Report: Deficiency Report
Function: Test, Adjust, & Balance
Date: 08/20/2025
Completed By: National TAB

PROJECT
08-18-25 QT #1101 SENECA, SC

QUIKTRIP
4705 SOUTH 129TH EAST AVENUE
TULSA, OK 74134

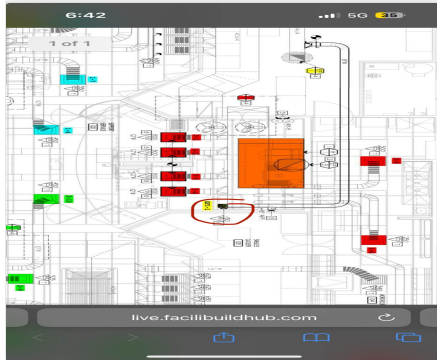
Issue Name : EF1-1 not installed
Description : To complete balance, EF1-1 needs to be installed. According to GC the SGRD will be installed later this week.
Created By : National TAB **Assigned To :** National TAB - Daniel Covaci
Status : Open
Priority : **Urgent** **Asset Tag :** EF1
Originated Date : 08/20/2025 - Chistian Moller - National TAB

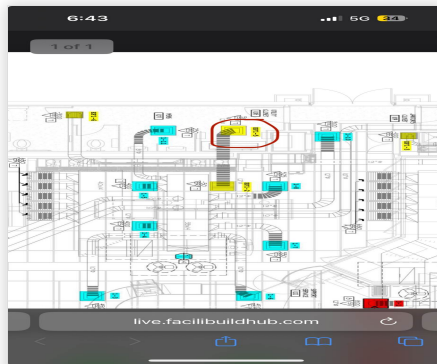
Issue Name : EF1-5 no flow
Description : EF1-5 did not have an airflow when total cfm for EF1 was being taken. Could not diagnose problem while on site.
Created By : National TAB **Assigned To :** National TAB - Daniel Covaci
Status : Open
Priority : Medium **Asset Tag :** EF1
Originated Date : 08/20/2025 - Chistian Moller - National TAB

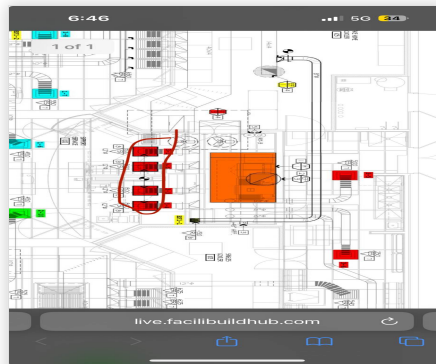
Issue Name : RTU 3 SGRD 1 through 4 not proper size
Description : SGRD's 1 through 4 are not the proper size and could not be balanced accordingly. RTU 3 is balanced to total.
Created By : National TAB **Assigned To :** National TAB - Daniel Covaci
Status : Open
Priority : Urgent **Asset Tag :** RT-3
Originated Date : 08/20/2025 - Chistian Moller - National TAB
